Service Bulletin No. 1068

COACH MODEL: T900 Series; T2100 Series; C2000 Series

BULLETIN TYPE: Product improvement

SUBJECT: Turn signal/hazard warning flasher

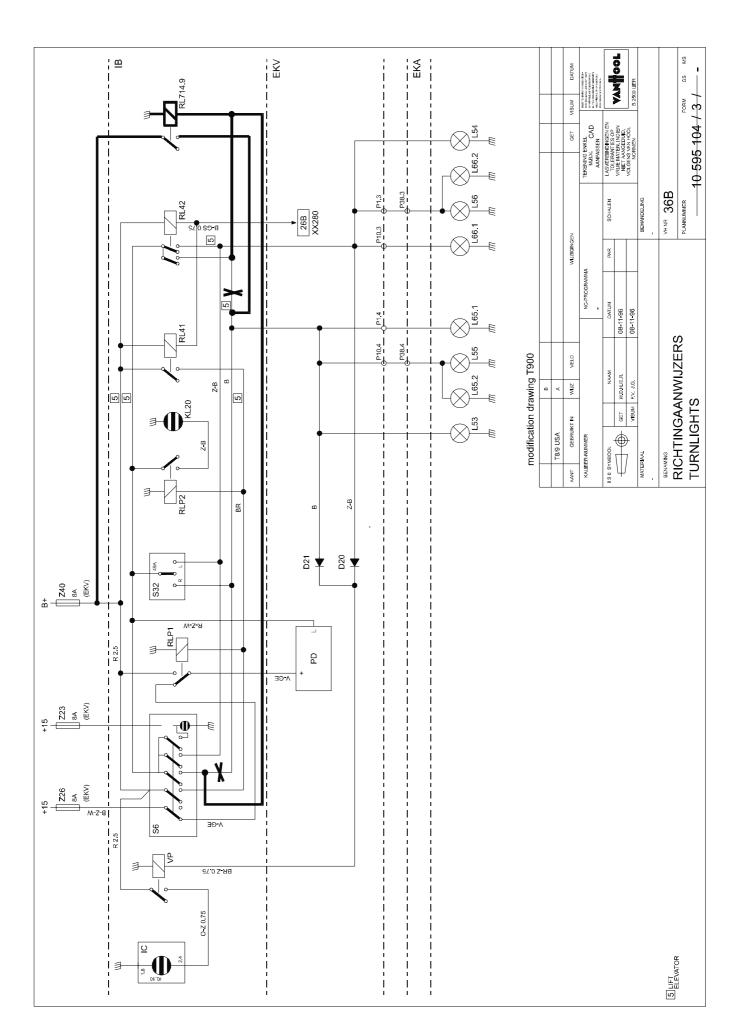
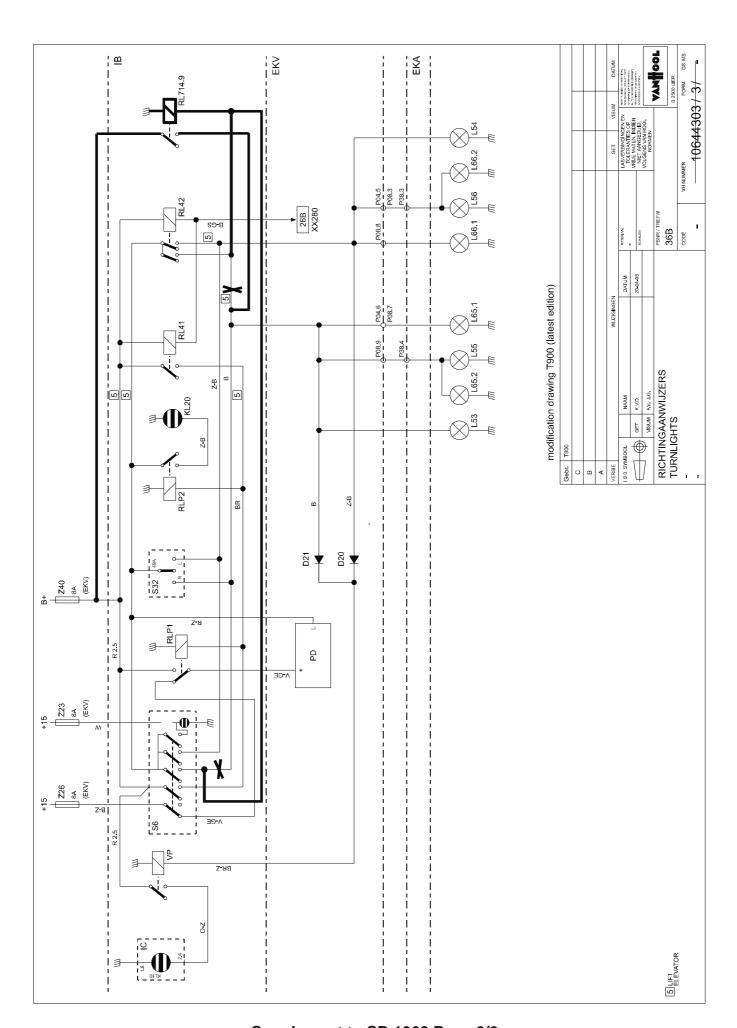
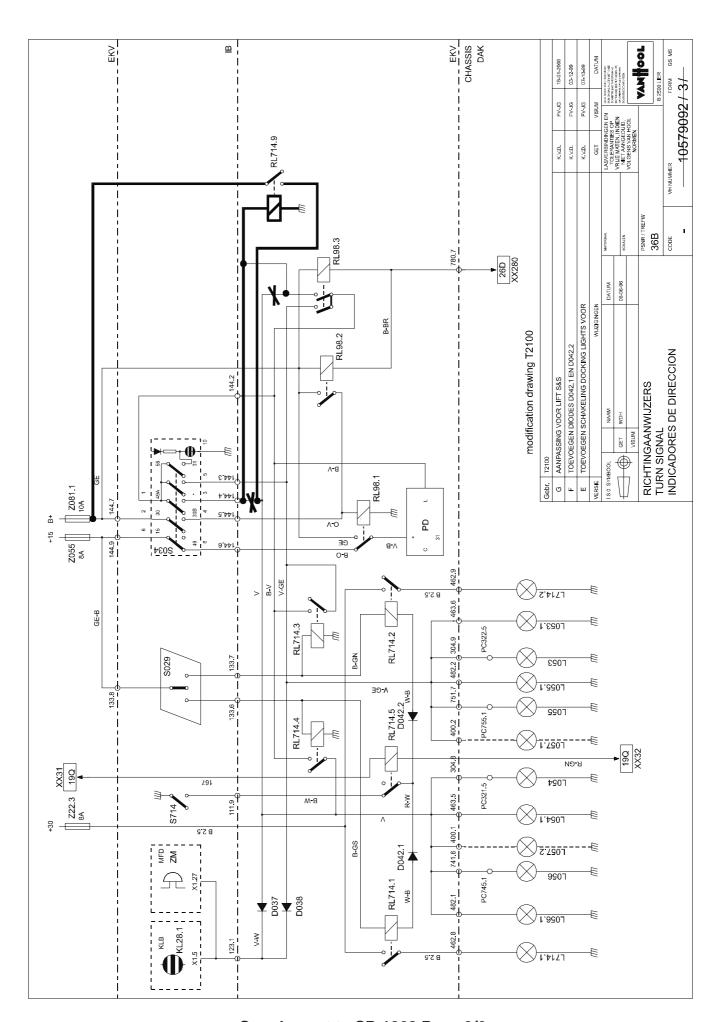
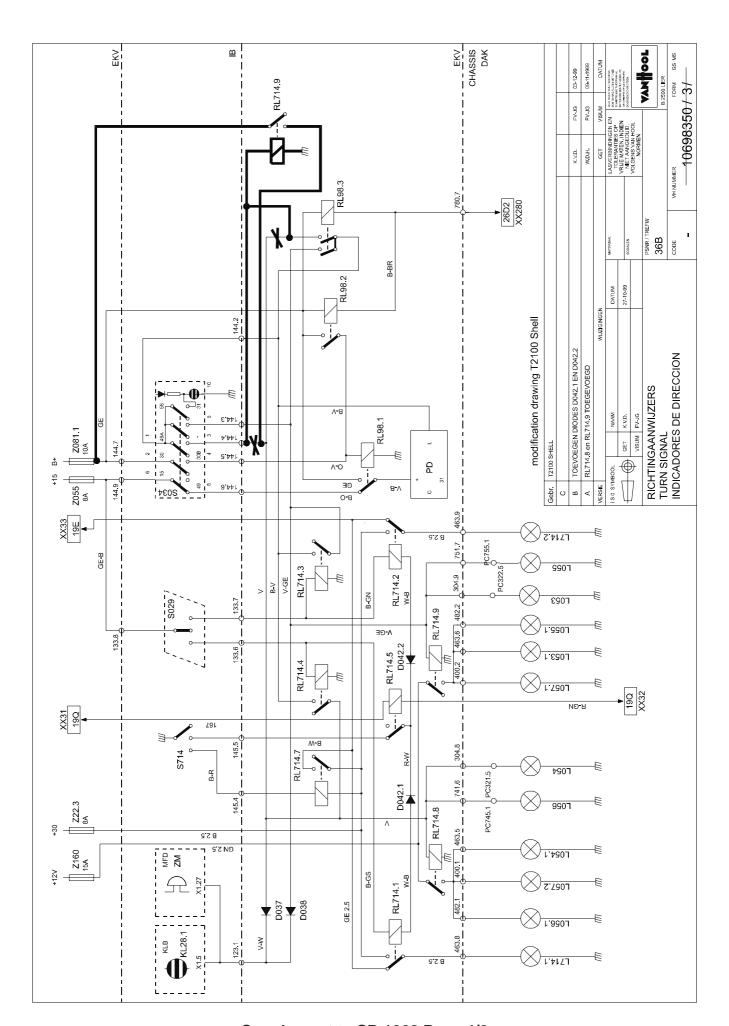
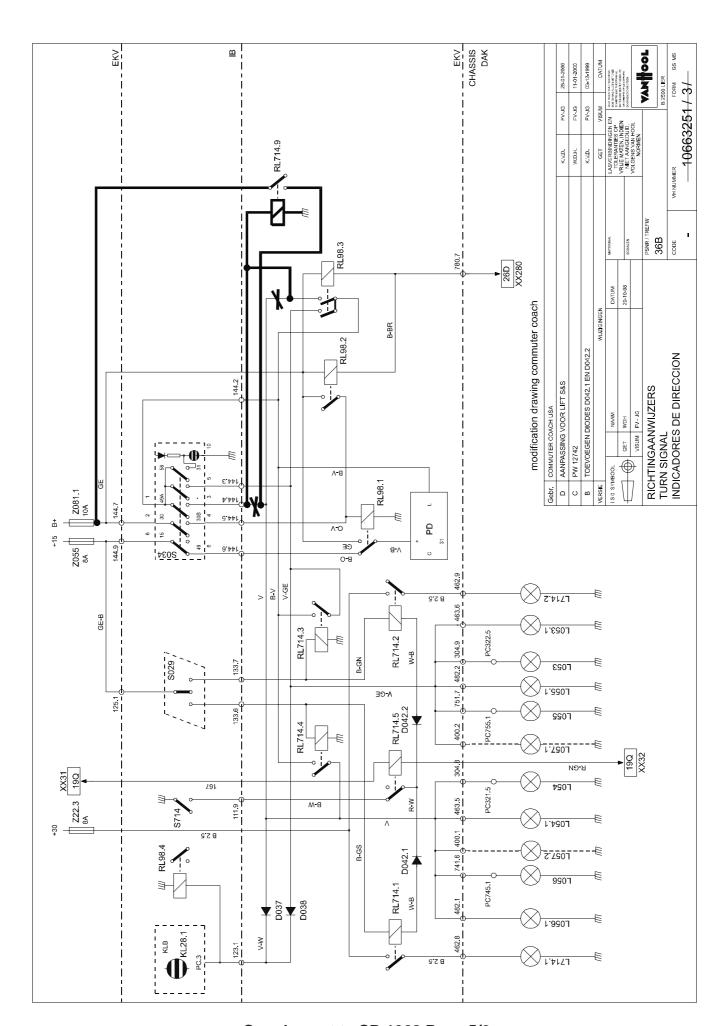
The conversion includes the installation of a supplementary relay which is activated by the hazard warning switch and, in case the coach is equipped with a wheel chair lift, by the « lift door open » signal. Once it is switched on, the relay takes over from the flasher the electric load of the hazard warning lights on one half of the coach.

- 1. Depending on installation conditions, install a supplementary relay holder or use a vacant relay holder from the relay rack in the main junction box.
- 2. Connect the wires as indicated on the applicable supporting wiring diagram(s) attached to this Bulletin. There is a separate diagram for each type of coach:
 - For early T900 coaches and T900 shells refer to wiring diagram VH 10595104 modified.
 - For T900 coaches with latest type junction box refer to wiring diagram VH 10644303 modified.
 - For T2100 coaches refer to wiring diagram VH 10579092 modified.
 - For T2100 shells refer to wiring diagram VH 10698350 modified.
 - For C2000 coaches refer to wiring diagram VH 10663251 modified.

With T900 coaches on which no wheelchair lift has been installed, relays RL41 and RL42 may be omitted.
